CITY OF NAPOLEON – Building & Zoning Division

Re. Sanitary sewer backup on your parking lot.

NOTICE

Date: 2-5-04
 Contractor: Tressler Pkg. Quality Inn
 #2395 Scott St.
 Inspected: Brent Dorman

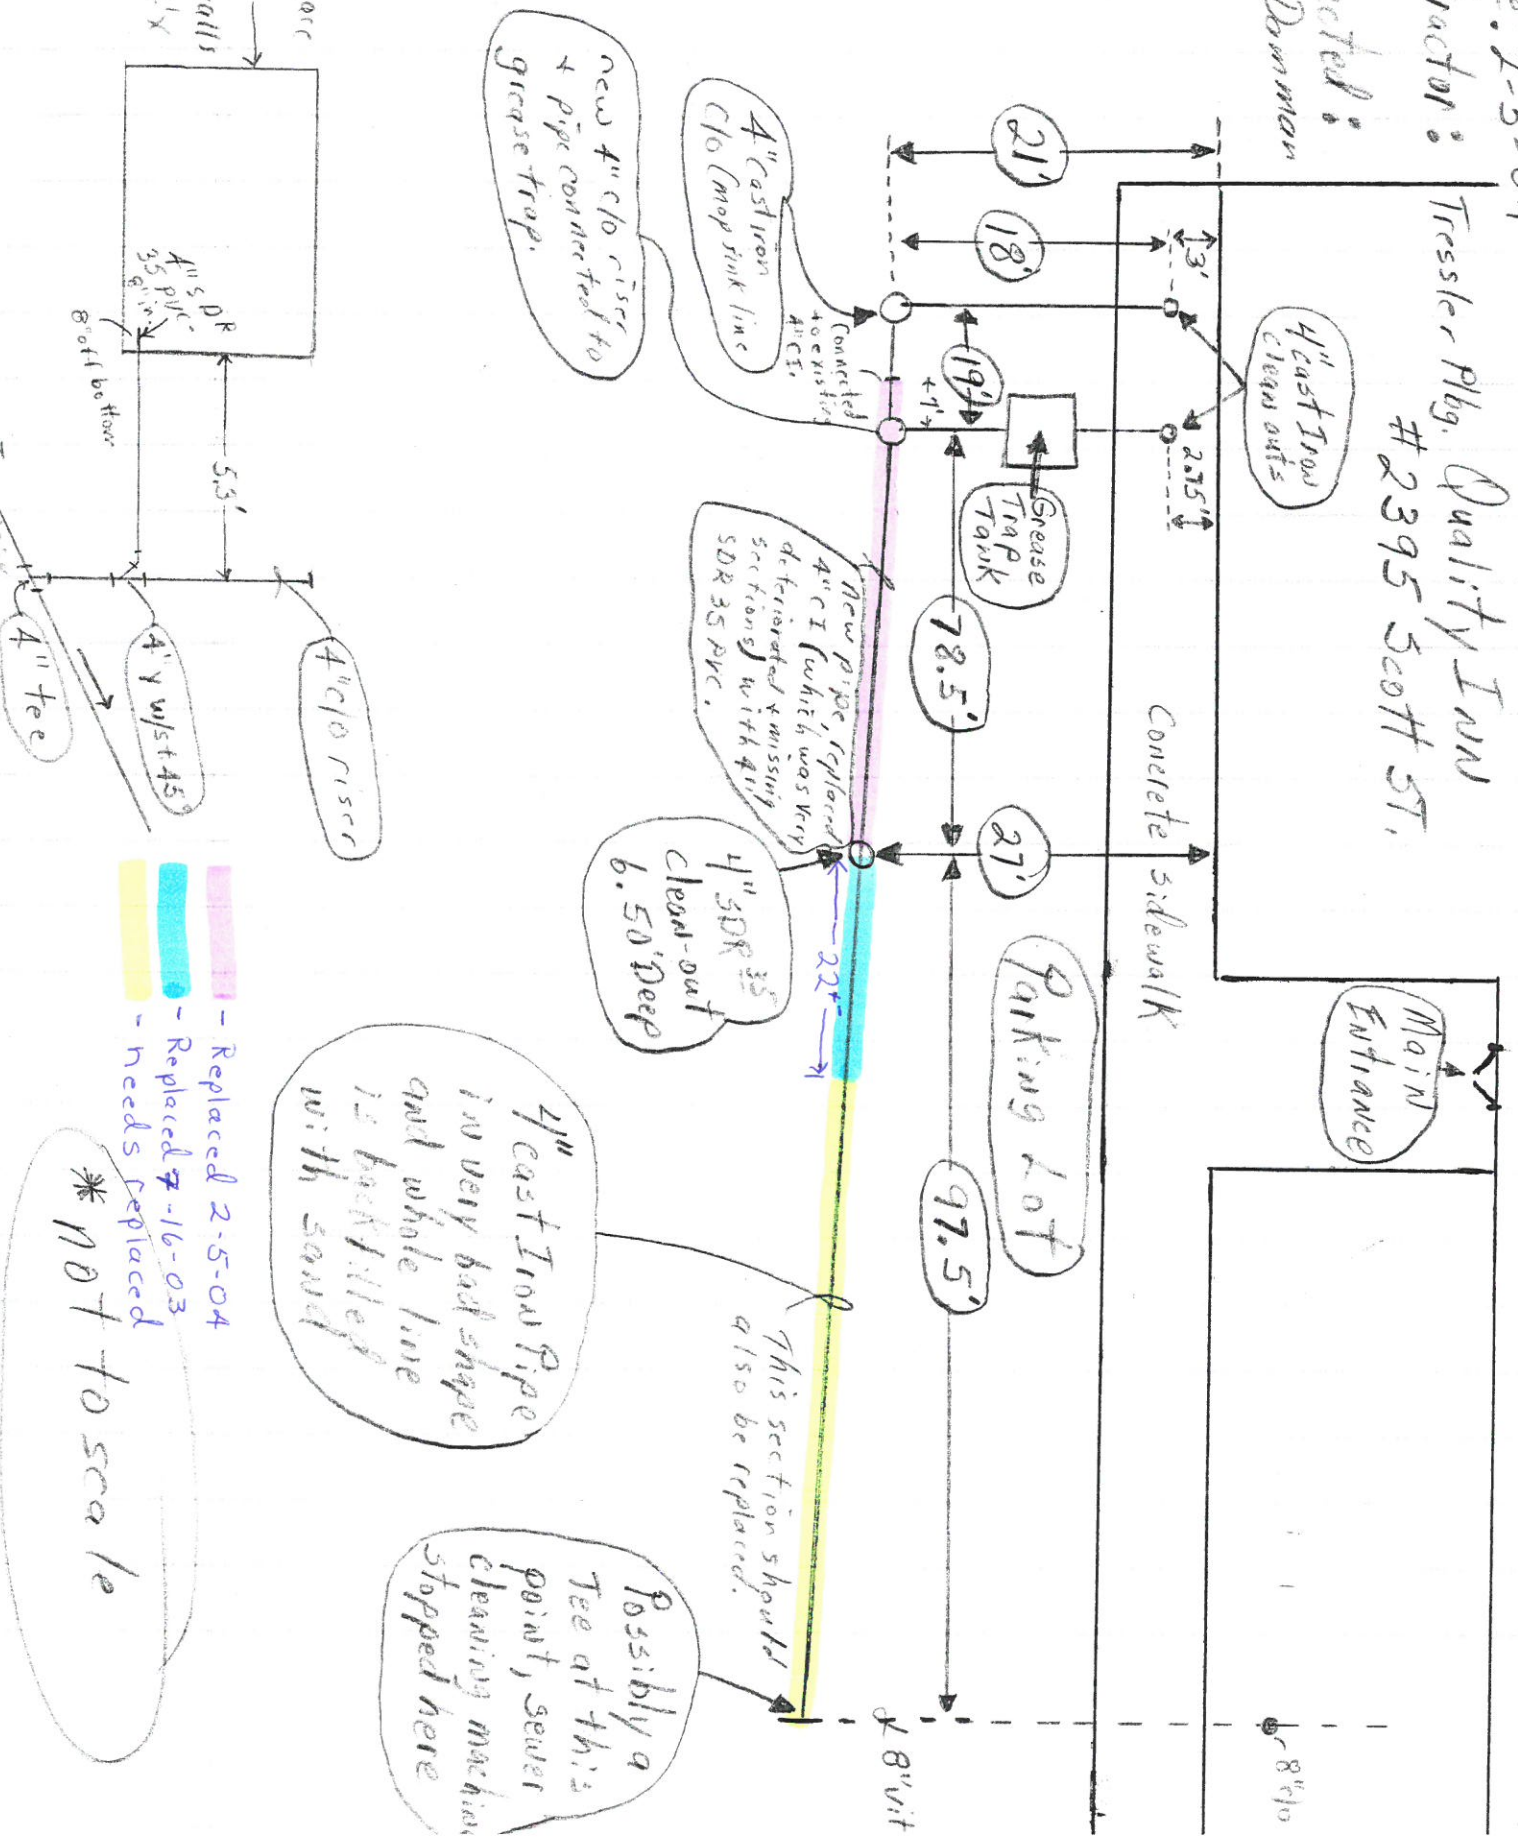
1. The sewer line is flowing currently.
2. The condition of the 4" cast iron line which was replaced was very poor. The flow line of the piping had rotted through along most of the length of pipe.
3. There remains approximately 75 feet of 4" cast iron piping which appears to be in the same condition as the piping which was replaced.
4. I would like to see the remaining 4 inch cast iron piping replaced by no later than ~~March 31st~~. ~~Therefore, I would like to continue this case until then.~~

Poured in place
 grease trap →
 6" concrete walls
 approx. 4'x4'x
 4' deep.

new 4" c/o riser
 + pipe connected to
 grease trap.

4" Cast Iron
 c/o (map sink line
 Connected
 to existing
 4" CI.

New pipe, replaced
 4" CI which was very
 deteriorated & missing
 sections with 4"
 SDR 35 PVC.

4" SDR 35
 clean-out
 6.50' Deep

4" Cast Iron Pipe
 in very bad shape
 and whole line
 is backfilled
 with sand

Possibly a
 Tee at this
 point, sewer
 cleaning machine
 stopped here

This section should
 also be replaced.

- Replaced 2-5-04
- Replaced 7-16-03
- Needs replaced

Owner agreed to have remainder
of sewer line replaced by June 30, 2004
